To: Planning Committee
From: Victor Wei,
Director, Transportation
Terry Crowe,
Manager, Policy Planning
Date: October 10, 2017
File: 08-4045-20-04/2017-
Vol 01
Re: **Proposed Changes: Steveston Area Plan, Village Heritage Conservation
Policies, Design Guidelines and Long-Term Bayview, Moncton and Chatham
Street Visions**

**Richmond Official Community Plan Bylaw 7100
Amendment Bylaw 9775
Steveston Area Plan (Schedule 2.4)**

Typical Cross-Section of Recommended Streetscape Design for Bayview Street

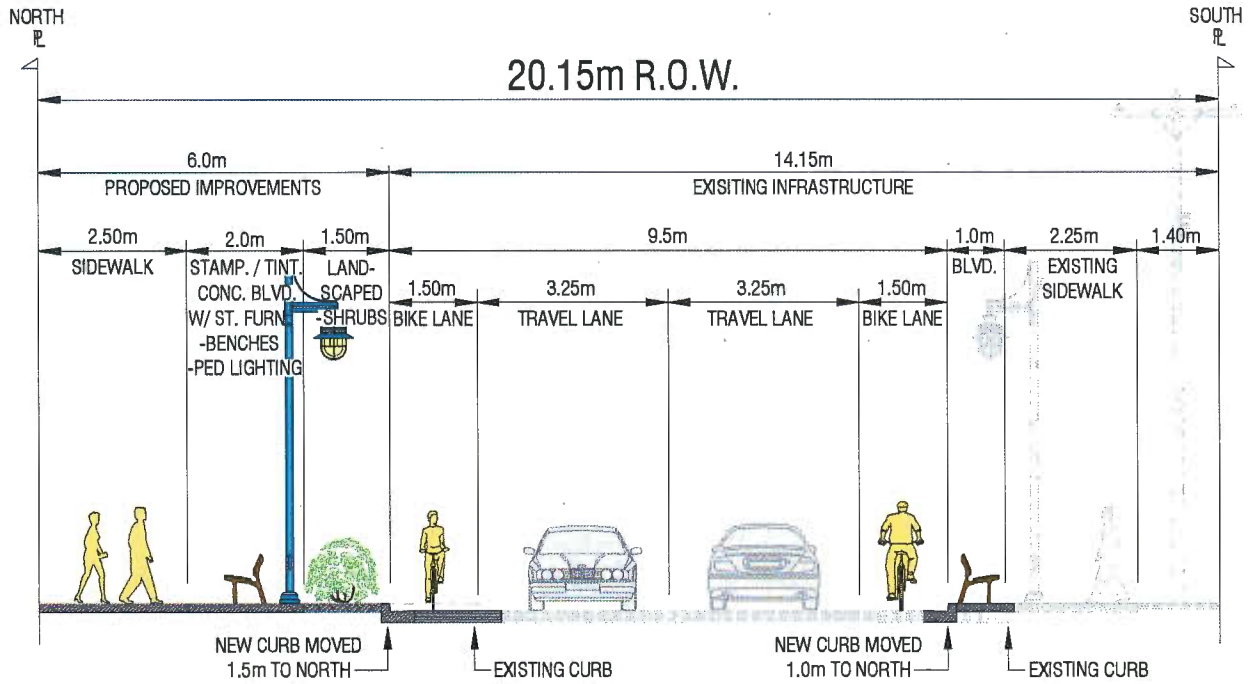
Staff Recommendation: Option 3, which originally comprised shifting both curbs, wider pedestrian realms on the north and south sides, the removal of on-street parking on the south side, and the provision of a two-way protected cycling facility on the south side, with the following modifications to address concerns identified by survey respondents:

- *Design of Cycling Facility*: modification of the proposed two-way on-street protected cycling facility on the south side to directional bike lanes on either side of the street, which would provide more convenient access for cyclists, minimize confusion for pedestrians at crossings, and be consistent with the proposed cycling facilities on Chatham Street. Both the westbound and eastbound bike lanes would be located on the street as there is insufficient right-of-way to accommodate off-street facilities while maintaining adequate width for the pedestrian realm. An on-street cycling facility is considered acceptable given the lower vehicle speeds of 30 km/h.

Attachment 9 illustrates a typical cross-section and plan view for the recommended modified Option 3 for Bayview Street. Attachment 10 indicates that recommended streetscape option could be implemented along the majority of both sides of the street (yellow shaded areas) with the exception of two areas where there would be private property impacts (pink shaded areas).

Existing and Future Riverfront Walkways and Connections

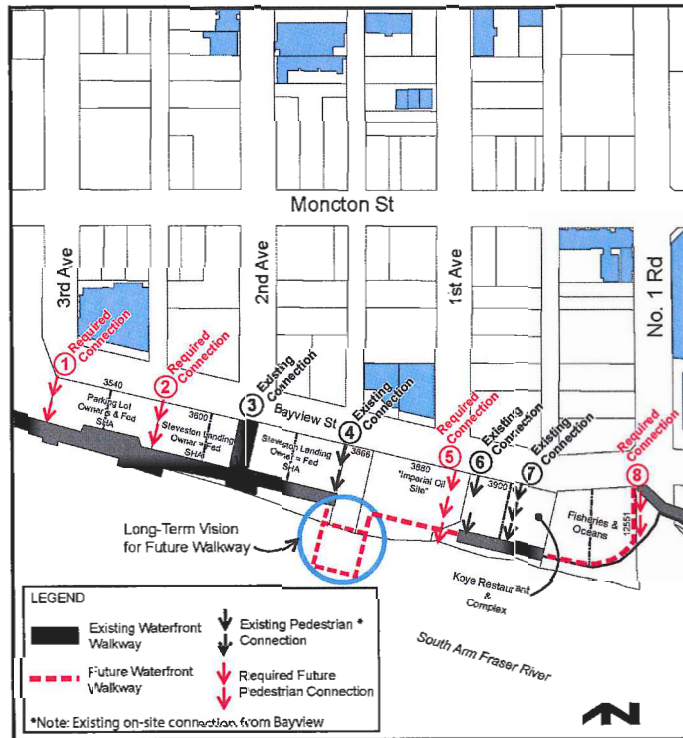
“Objective 6: Work toward public accessibility for pedestrians to and along the waterfront between 3rd Avenue and No. 1 Road through pathways that connect Bayview Street to the water’s edge, and completion of a continuous boardwalk.

- a) Work with the Federal Government, Steveston Harbour Authority and other property owners to establish new pedestrian connections at the following street and lane ends.
 - Pedestrian connections at road ends at the south foot of No. 1 Road, 1st Avenue and 3rd Avenue will meet the following guiding principles for universal accessibility and urban design:
 - Create a public right-of-passage with a minimum width of 5.6 m including 1.0 m setbacks from adjacent buildings
 - Building signage projections up to 1.0 m into any building setback and detailed as per Steveston Development Permit Area Design Guidelines

Pedestrian Connections at Road Ends

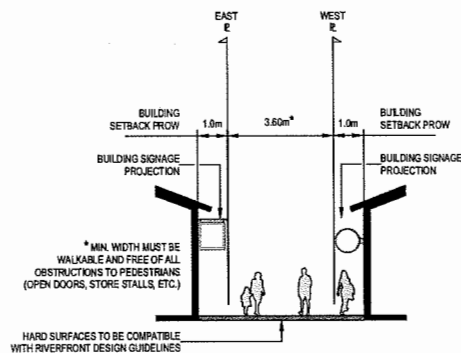
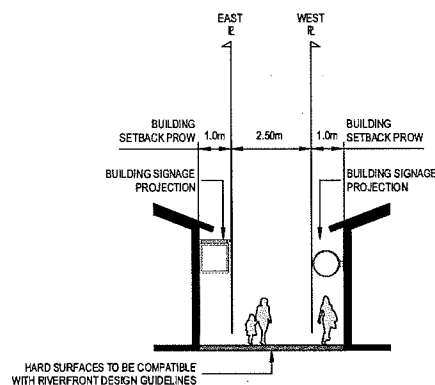
- A minimum of 5.6 m of the above minimum 5.6 m public right-of-passage must be free and clear of obstructions, including but not limited to: building projections (except for signage), doors, patios, store stalls.
- Accessible hard surfaces with materials compatible with “Steveston Village Riverfront” Development Permit Area design guidelines (see: Section 9.3.2.2.b).
- Pedestrian connections materials and surface treatments designed to be safe and accessible for all users.
- Undertake enhancements to existing pedestrian connections in accordance with these guidelines where appropriate.

- Connections at the lane ends between No. 1 Road and 1st Avenue, between 1st Avenue and 2nd Avenue; and between 2nd Avenue and 3rd Avenue, will meet the following guiding principles for universal accessibility and urban design:
 - Create a public right-of-passage with a minimum width of 4.5 m including 1.0 m setbacks from adjacent buildings
 - Building signage projections up to 1.0 m into any building setback and detailed as per Steveston Development Permit Area Design Guidelines
 - A minimum of 4.5 m of the above minimum 4.5 m public right-of-passage must be free and clear of obstructions, including but not

Waterfront Walkway at High Water Mark

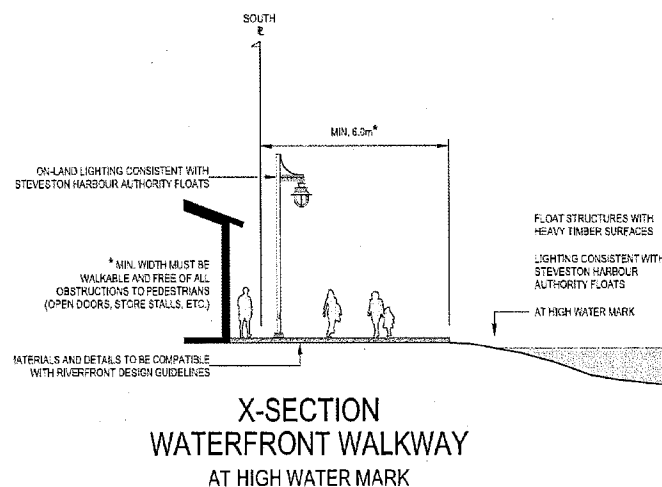
- b) Work with the Federal Government, Steveston Harbour Authority and other property owners to establish waterfront walkway connections at, and above, high water mark.
- Walkway sections that are situated at high water mark elevation will meet the following guiding principles for universal accessibility and urban design:
 - Minimum 6.0 m in width.
 - Connected to walkways above, at the street end nodes, with gangways to create accessible access points.
 - Float structures with heavy timber surfaces.

- Materials and details compatible with “Steveston Village Riverfront” Development Permit Area design guidelines (see: Section 9.3.2.2.b).
- Waterfront walkway materials and surface treatments designed to be safe and accessible for all users.
- Lighting to enable nighttime use consistent with Steveston Harbour Authority floats.
- Undertake enhancements to existing waterfront walkway connections in accordance with these guidelines where appropriate.

Waterfront Walkway Above High Water Mark

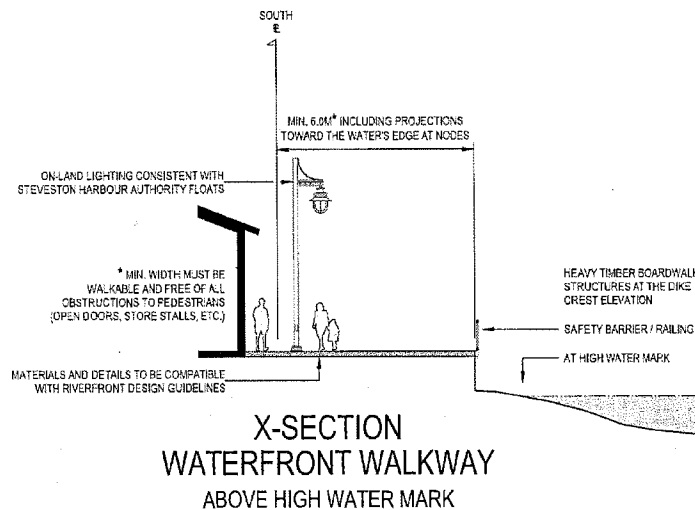
- Walkway sections that are situated above high water mark elevation will meet the following guiding principles for universal accessibility and urban design:
 - Minimum 6.0 m in width including projections toward the water’s edge at nodes (i.e. both street end and lane end connections).
 - Heavy timber boardwalk structures at the dike crest elevation.
 - Materials and details compatible with “Steveston Village Riverfront” Development Permit Area design guidelines (see: Section 9.3.2.2.b).
 - Waterfront walkway materials and surface treatments designed to be safe and accessible for all users.
 - Lighting, seating and other site furnishings, as appropriate, at nodes.
 - Undertake enhancements to existing waterfront walkway connections in accordance with these guidelines where appropriate.

Steveston Village Character Area Map

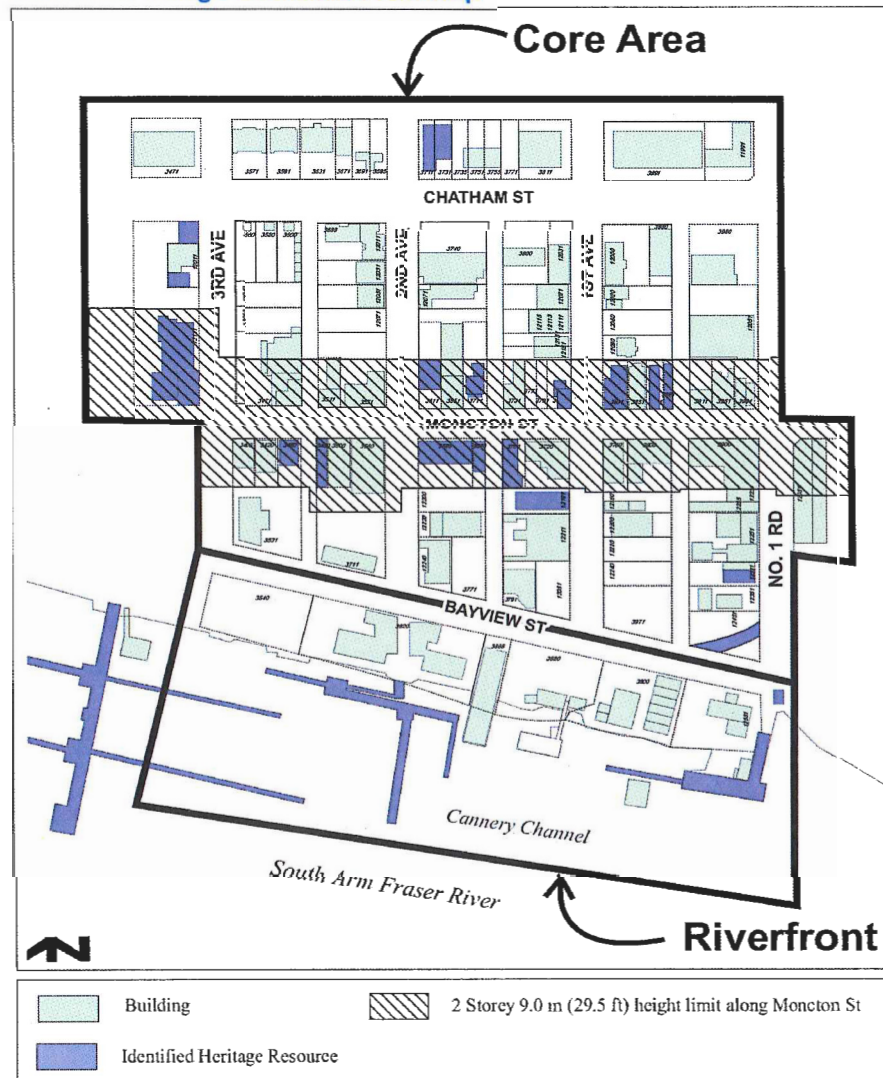
vi) In Section 9.3 Additional Development Permit Guidelines: Character Area Guidelines, repeal and replace the Steveston Village Character Area Map as follows:

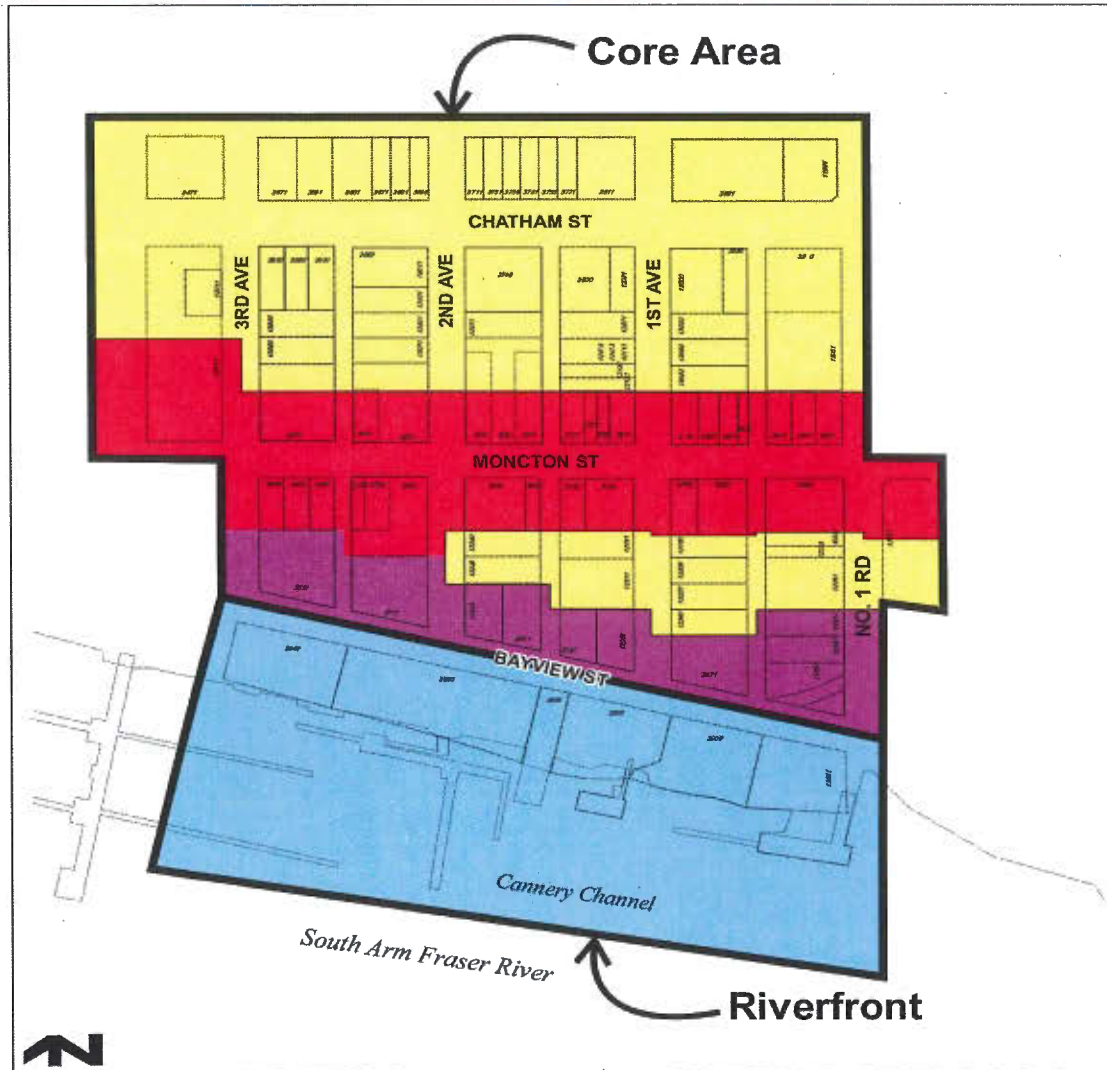
- k) On Bayview Street (north side), to achieve a suitable transition in built form moving north from Bayview Street to Moncton Street:
 - For the north 50% of any lot depth, a density of 1.2 F.A.R. and 3 storeys maximum building height (containing a parkade structure and two storeys above) is supported.

- For the south 50% of any lot depth (nearest to Bayview Street which is the dyke) a density of 1.2 F.A.R. and 2 storeys building height as viewed

from Bayview Street is supported as the parkade structure below the two storeys will predominantly be concealed by the grade difference.”
